Attachment B  
Response to Comments

Green Valley Road/ Weber Creek Bridge  
Replacement Project  
(CIP #77114)

## Comments and Responses on the Green Valley Road at Weber Creek Replacement Project Initial Study/Mitigated Negative Declaration

Figure 4. Project Vicinity and Noise Measurement Sites

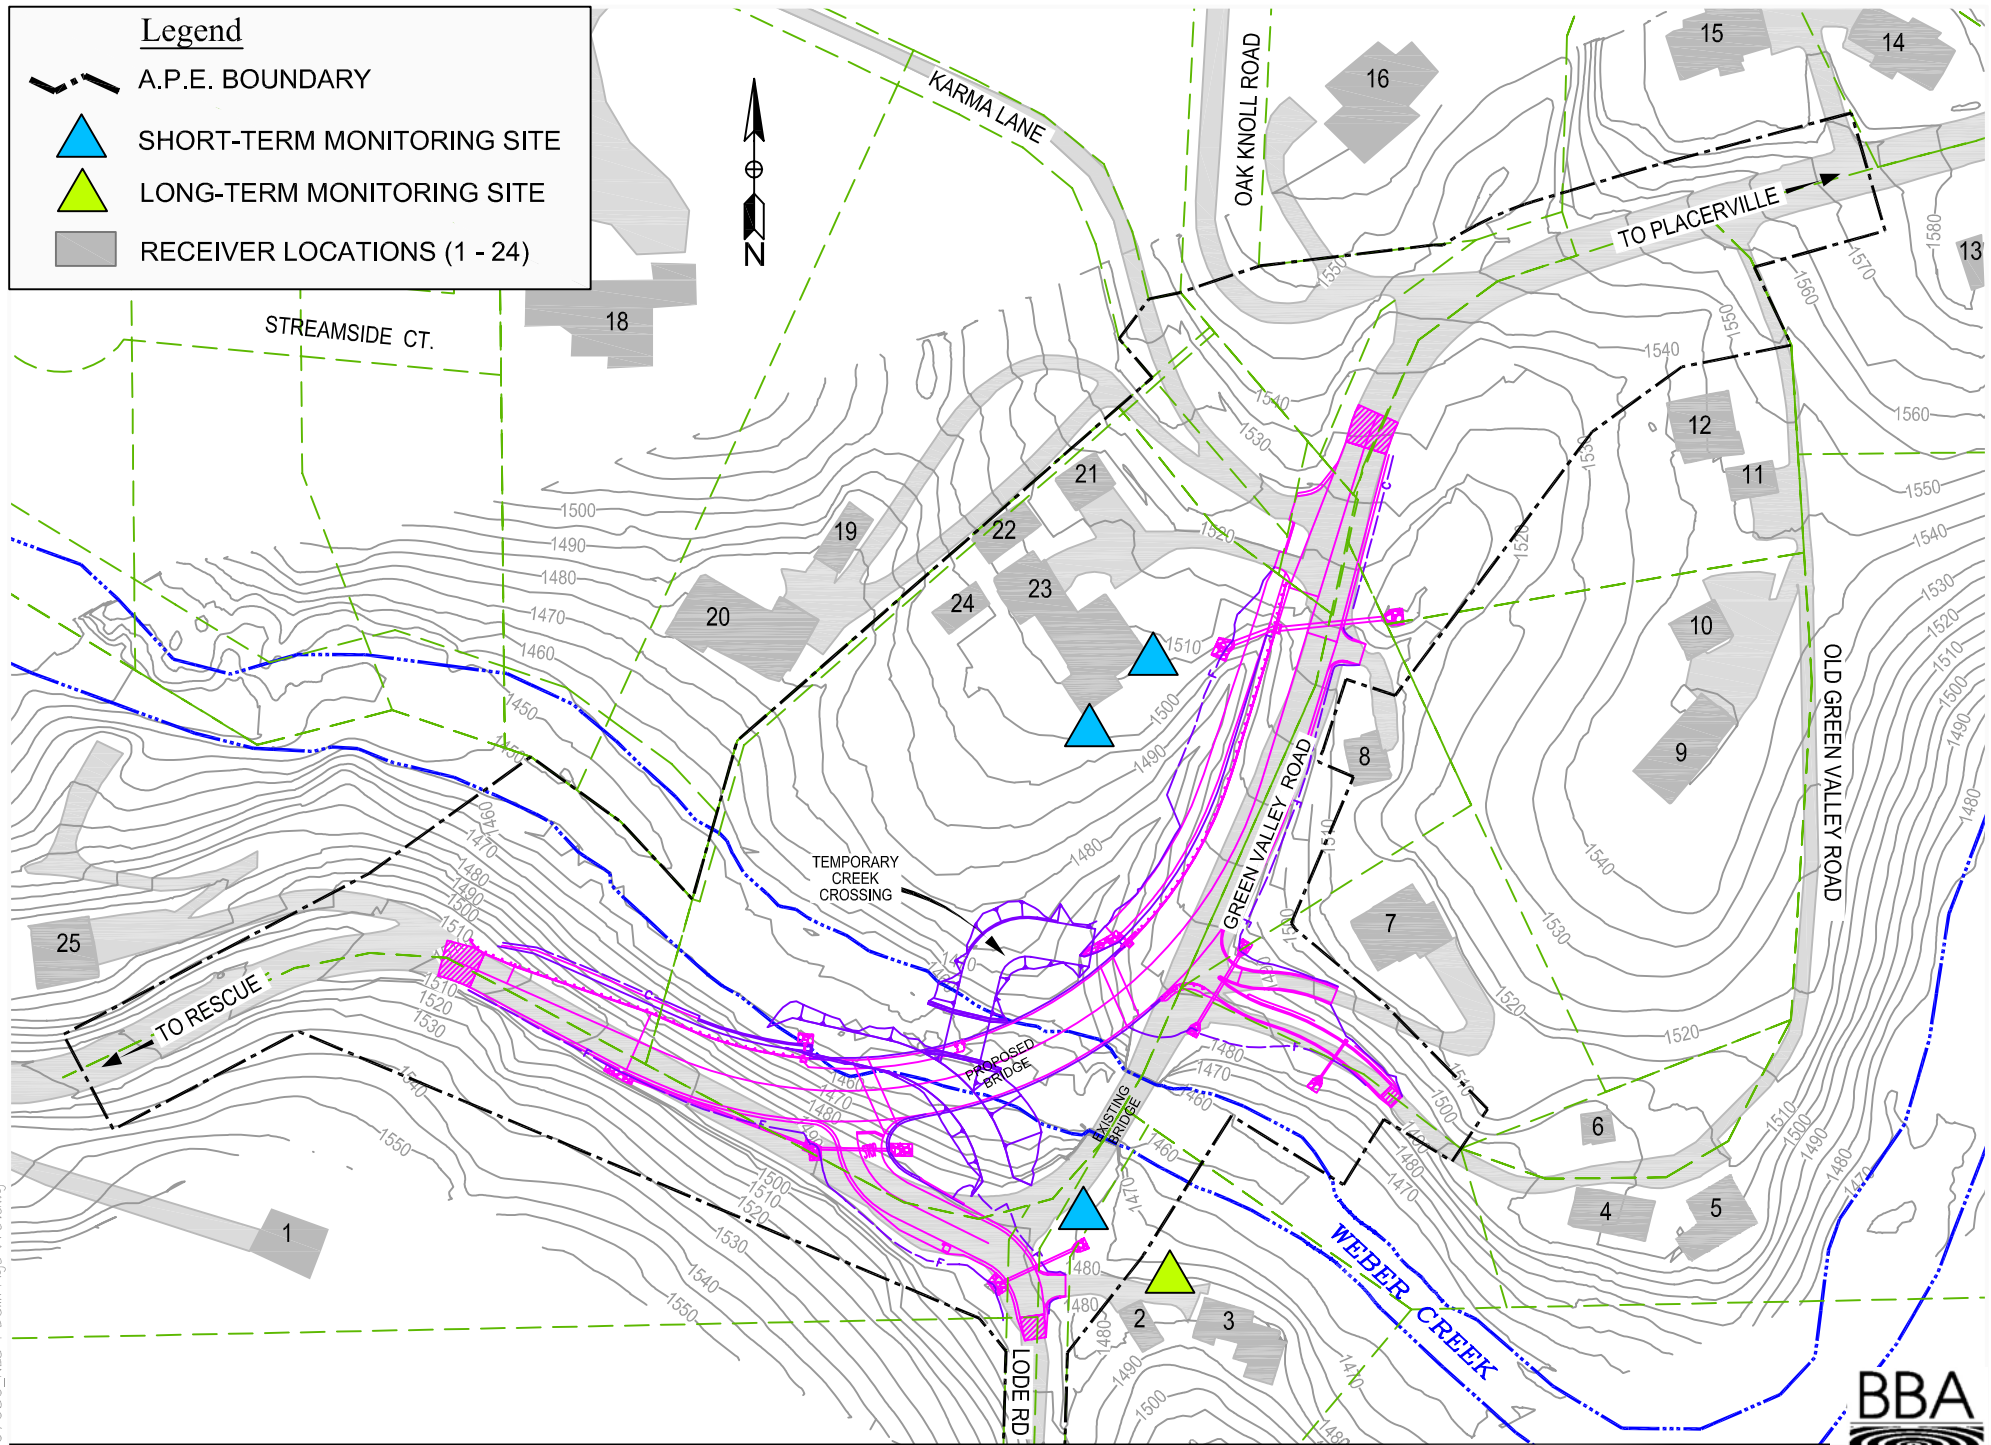
- c. I was concerned as to the location, the number of testing receivers, and duration of the data recording for this test procedure. Figure 4, Project Vicinity and Noise Measurement Sites, show short-term monitoring site, Long-Term monitoring site, Receiver locations, but do not give any data relating to the duration of data recording for each of them. Depending on the duration of data gathering on the short-term, I would think that our site would have a long term data recording. This may not be an issue.

Short-term traffic noise level measurements were conducted for 15 minutes at three locations along Green Valley Road on March 7, 2008, and February 27, 2009. To quantify overall ambient noise levels, BBA performed a continuous noise measurement over a 47-hour period on March 7, 2008 from 12 p.m. to March 9, 2008 at 8:30 a.m., at the north edge of the driveway at 7280 Lode Road. The purpose of the noise measurements was to determine the accuracy of the TNM in predicting traffic noise at the project site.
